Project	IEEE 802.16 Broadband Wireless Access Working Group < http://ieee802.org/16 >	
Title	A MAP IE for H-ARQ and SDMA Allocation in AAS Zone	
Date Submitted	2005-01-26	
Source(s)	InSeok Hwang, Jaehee Cho, Seungj Maeng, JangHoon Yang, Hoon Huh, SangHoon Sung, Jaeho Jeon, Soonyoung Yoon Samsung Electronics, Inc.	is91.hwang@samsung.com
	Ran Yaniv, Tal Kaitz Alvarion Ltd.	ran.yaniv@alvarion.com
	Dave Pechner, Doug Dahlby, Todd Chauvin ArrayComm Inc.	dpechner@arraycomm.com
Re:	Call for reply comments (Original Comment # 2189)	
Abstract	A new efficient Normal MAP IE supporting for Hybrid ARQ and SDMA allocation in AAS zone is proposed.	
Purpose	Adoption in IEEE 802.16e_D6	
Notice	This document has been prepared to assist IEEE 802.16. It is offered as a basis for discussion and is not binding on the contributing individual(s) or organization(s). The material in this document is subject to change in form and content after further study. The contributor(s) reserve(s) the right to add, amend or withdraw material contained herein.

A MAP IE for H-ARQ and SDMA Allocation in AAS Zone

Fig. 1. Proposed SDMA Allocation Scenario

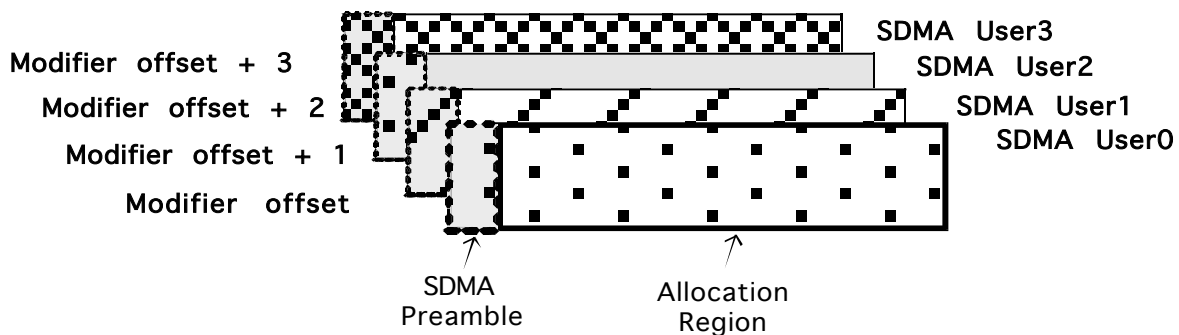
The burst allocation region of SDMA users can be fixed for scheduling simplicity and lower signaling overhead. In addition, modifier index for SDMA preamble can be extracted from description order of SDMA users. The proposed solution can be summarized as follows

- 1) Introduce Extended IUC in DL/UL MAP for SDMA allocation (not available yet)
- 2) Use '1' of '5' reserved bits in AAS_IE() to specify modifier type, "Time" or "Freq." shift
- 3) Describe the shared 2D (DL) or 1D (UL) allocation regions
 - Specify {CID, modulation/coding schemes (IUC or H-ARQ)} fields

Figure XXX – Pilot patterns for AAS mode in AMC zone. Symbol offset is relative to the beginning of the zone. Pilot polarity for each pattern is given in brackets.

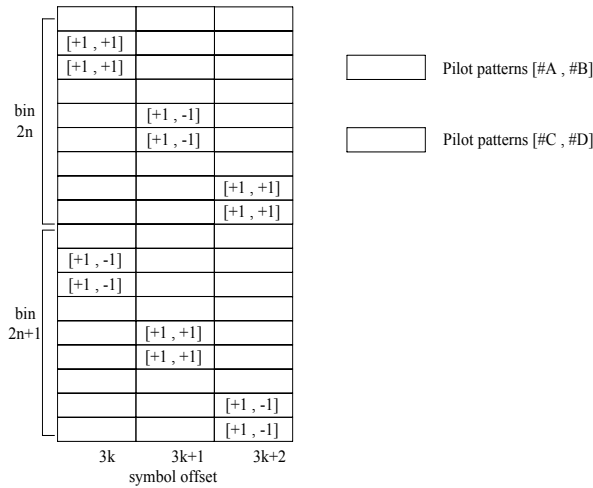
8.4.6.3.2 AMC support for SDMA

The pilots in an AMC AAS zone are regarded as part of the allocation, and as such shall be beamformed in a way that is consistent with the transmission of the allocation's data subcarriers. In an SDMA region, the pilots of each allocation may correspond to a different pilot pattern. A pilot pattern consists of location and polarity. The pilot patterns are depicted in figure XXX. Data subcarriers shall be punctured to obtain patterns #2 and #3. Subcarriers shall only be punctured if there is an allocation associated with the corresponding pattern, as described in the AAS SDMA DL IE() and AAS SDMA UL IE(). Only MSSs that support all four pilot patterns, as indicated by their capability in 11.8.3.7.X, shall be assigned allocations in an SDMA region where pilot patterns #2 and #3 are used. Data subcarriers shall be punctured after constellation mapping in the case of CC encoding, and prior to constellation mapping in the case of CTC encoding. In the latter case, the FEC block shall be truncated to accommodate the punctured subchannel structure, and the data subcarrier enumeration of Eq. (116) shall not be applied. Instead, data subcarriers within a slot shall be enumerated starting from the first OFDMA symbol at the data subcarrier that is lowest in frequency, continuing in ascending frequency order throughout the slot's subcarriers in the same symbol, then going to the next symbol at the subcarrier lowest in frequency, and so on.

1. Change text on page 618 lines 5-9 of 802.16-2004, to the following text

$$\begin{aligned} \operatorname{Re}\{c_k\} &= \frac{8}{3} \left(\frac{1}{2} - w_k \right) \cdot p_k \\ \operatorname{Im}\{c_k\} &= 0 \end{aligned} \quad (135)$$

where p_k is the pilot's polarity (as described in section 8.4.6.3.2) for SDMA allocations in AMC AAS zone, and $p_k = 1$ otherwise.
